GOVERNMENT/INDUSTRY AERONAUTICAL CHARTING FORUM 07-02 Charting Group

RECOMMENDATION DOCUMENT

FAA Control # 07-02-202

Subject: Inconsistent and Incomplete Charting of STAR Holding Patterns

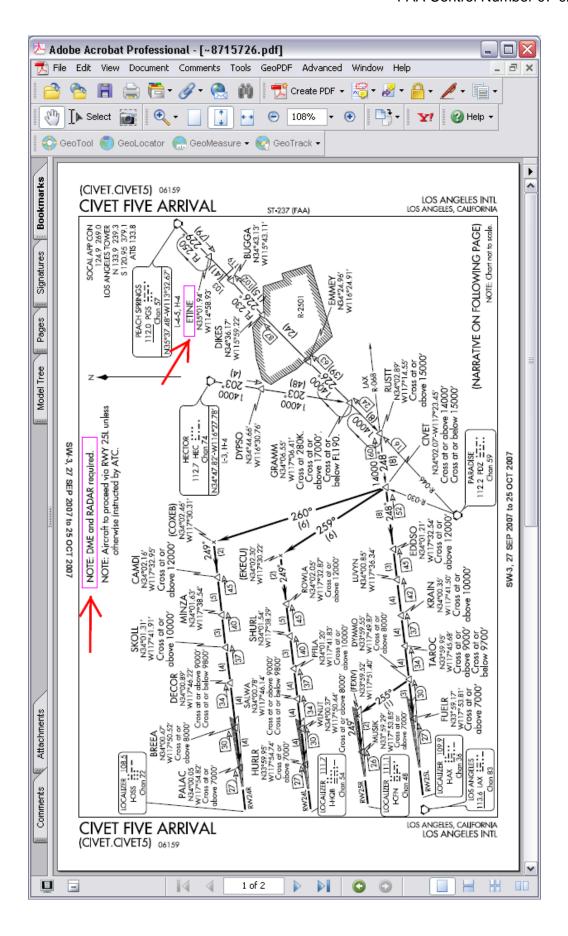
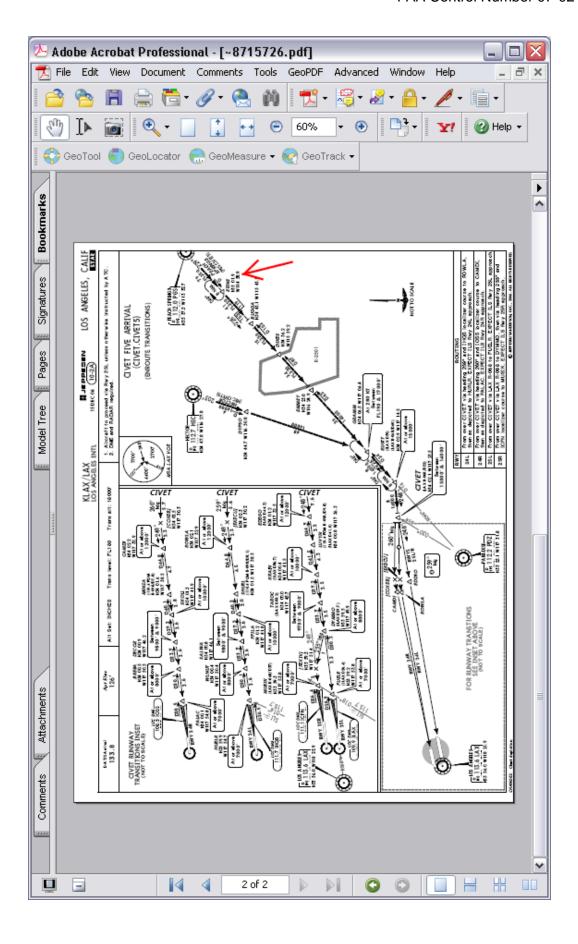
Background/Discussion: Attached are the NACO and Jeppesen charts for the CIVET FIVE (STAR) Arrival to KLAX. For purposes of this discussion, the ETINE radial/DME fix and holding pattern serve as the example of the issue. Note that ETINE is a radial/DME fix only; i.e., there is no cross-radial option to determine the fix. Thus, DME is mandatory to execute the holding pattern. But, the NACO chart shows no DME holding information. We are advised this is because NACO lacks a charting specification to chart DME holding information on STAR charts. Historically, such DME holding fixes would contain the DME distances within the holding oval icon. In this case it should be "79/71" since the source indicates 8 mile legs.

The Jeppesen chart shows "8 nm" within the oval. We presume Jeppesen elected to chart the actual value rather than "79/71" because of the reality that most aircraft holding at ETINE today would be using RNAV to substitute for the ground-based facilities. Nonetheless, this is still a ground-based VOR/DME STAR.

Also, source provides an unnecessarily short leg length for holding at the minimum specified flight level of FL 250. (This minimum flight level of FL 250 is confusing on the NACO chart in that it appears within the holding oval.)

If this were an RNAV STAR source would show a leg length of 12 n.m. This is because of an inconsistency in FAAO 7130.3A in the selection of leg lengths for DME holding and GPS (RNAV) holding.

- 1. NACO charting specifications be revised to require publication of DME leg lengths on all instrument procedure charts when specified on source.
- That both NACO and Jeppesen charts be required to chart both DME and RNAV leg lengths on ground-based STAR charts. In this case, "79/71 (8)" would best serve all users.

- 3. That source for DME holding on en route and arrival/departure charts use the greater of DME or GPS leg length selection. In this ETINE example, the recommended charting would then become "79/67 (12)."
- 4. The AIM be revised accordingly to provide necessary explanatory guidance to pilots.
